ADDENDUM NO. 1

CONCRETE DRIVEWAY REPLACEMENT 404 E. VINE, MACON, MISSOURI

Date: Tuesday, June 7, 2022

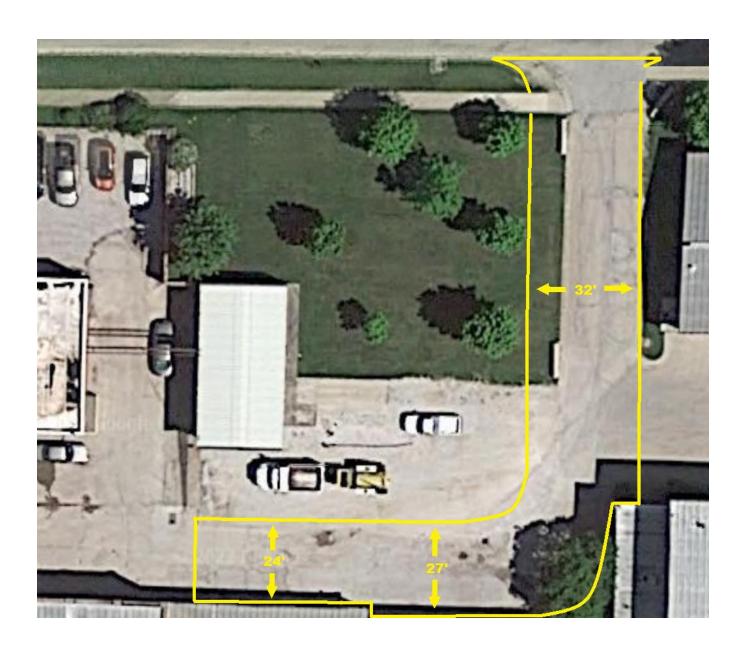
^{*}Please note the expansion of concrete from the current driveway extends 109' south of the sidewalk to the west turning radius.
